Lower Thames Crossing

Thurrock Council Comments on Applicant's Submissions at Deadline 6 (D6)

17 November 2023

Figure D.2.1: Spiral Marking and Lane Allocation Orsett Cock (also showing Order Limits in red outline)

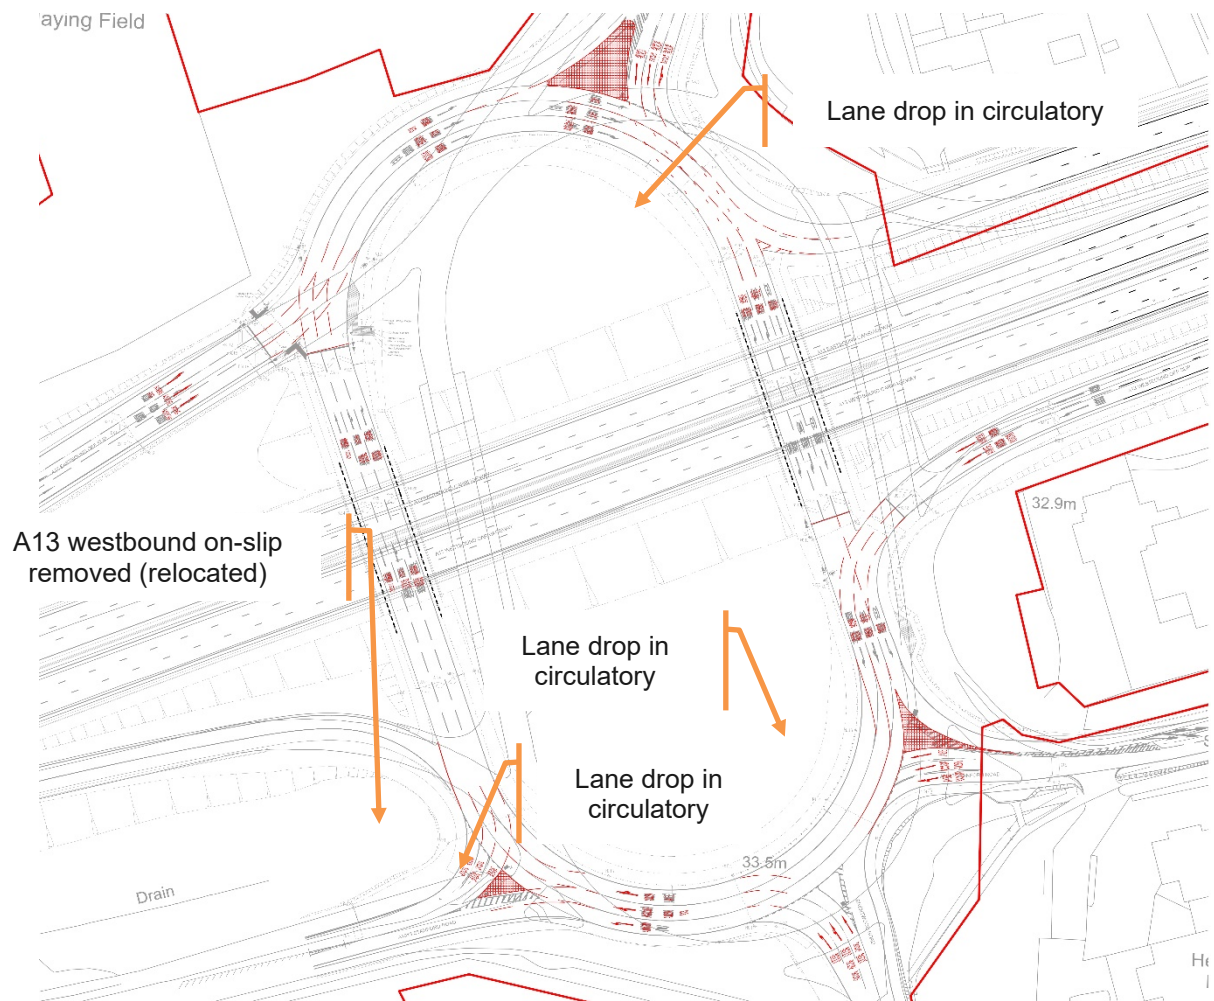
- D.2.7. A further change that has been included in the updated VISSIM model is a series of 'Lane Drops', included to the Orsett Cock circulatory to create a spiral layout.
- D.2.8. These amendments to the lane markings improve the traffic flow on the circulatory carriageway, particularly on the approach to conflict points. The spiral markings prevent traffic lane weaving as traffic seeks to move across lanes to depart from the circulatory. Lane drops have been added after the A128 Brentwood Road (North) approach; after the A13 East approach; and, at the A1013 West approach.
- D.2.9. In addition, the lane allocation on the approaches to the Orsett Cock Junction has been revised to provide a better distribution of traffic flow across the available lanes. **Figure D.2.1** below shows the lane marking changes that have been modelled.

Figure D.2.2: Signalised junction for Stanford Road / A13 westbound on-slip

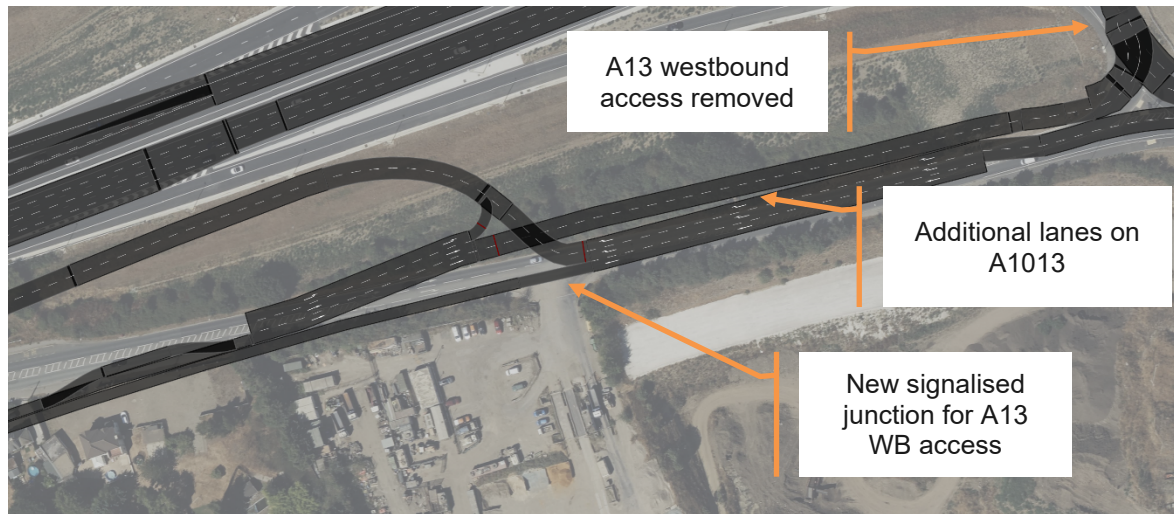
D.2.11. To reduce delays on this arm, the A13 WB on-slip has been removed from the Orsett Cock Junction in the VISSIM model and relocated so that the A13 westbound on-slip is provided from the A1013 Stanford Road (West) as shown in Figure D.3 below.

Figure D.3.1: Comparison of LTAM with VISSIM v3.6T. 2030 PM Peak Hour (1700-1800). Delay per Vehicle (seconds)

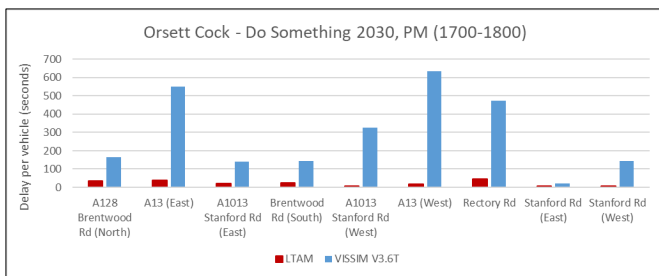
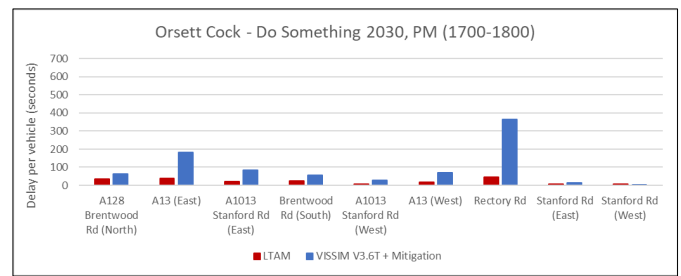
D.3.6 **Figure D.3.1** and **Figure D.3.2** below show this data graphically and clearly show the lack of alignment between the delays forecast by LTAM and VISSIM v3.6T, but a significant improvement towards the convergence between the two models with the additional mitigation tested in VISSIM v3.6T + Mitigation.

Annex 2 LTC and A13 off-slip approach arms

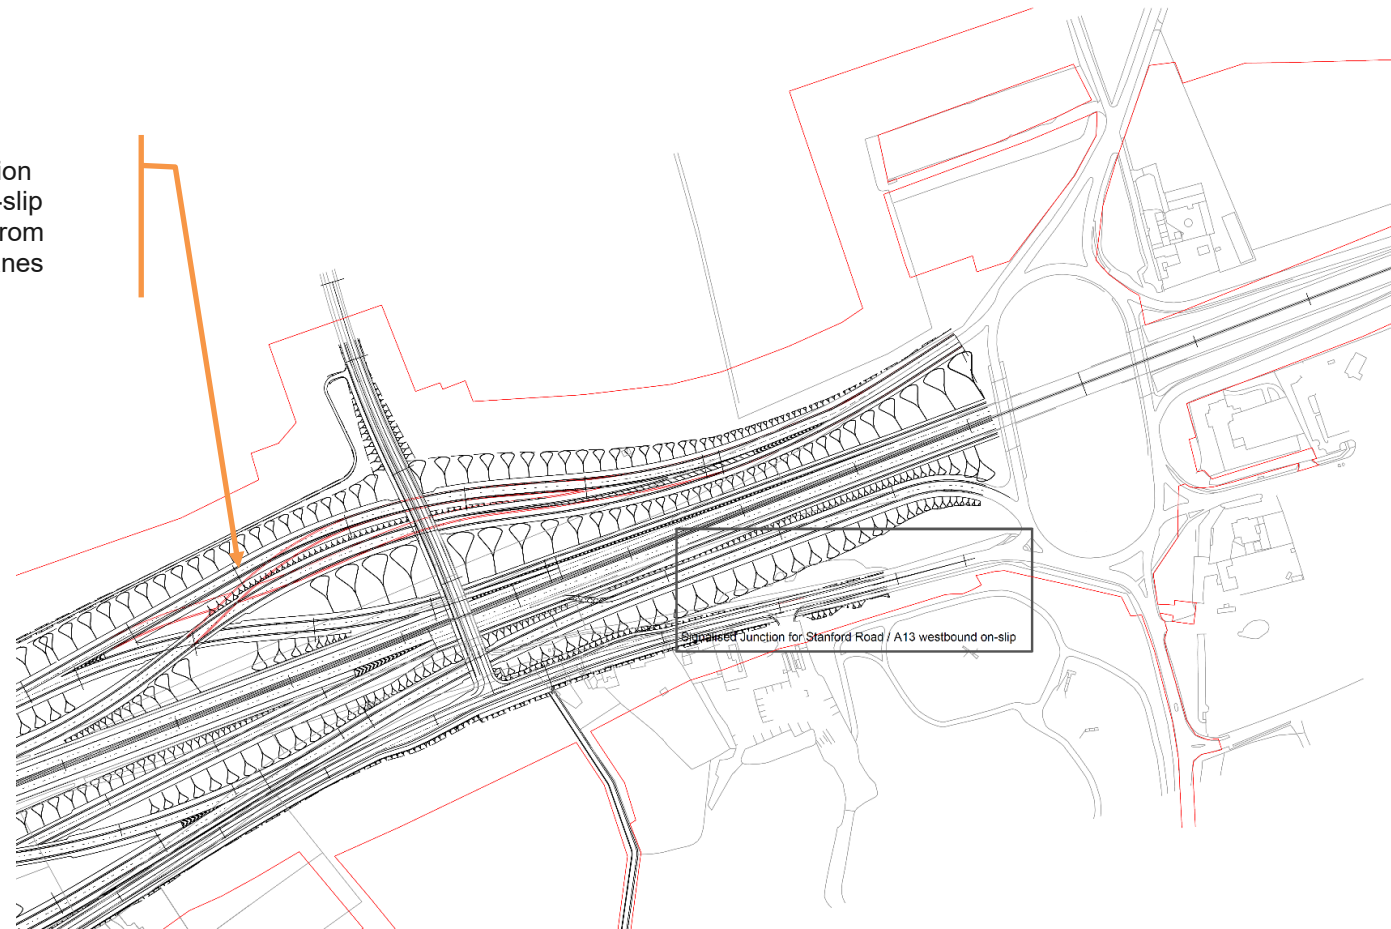
Change to lane allocation on junction approach – Traffic from A13 EB off-slip arrives to nearside lane and traffic from LTC arrives to middle and offside lanes
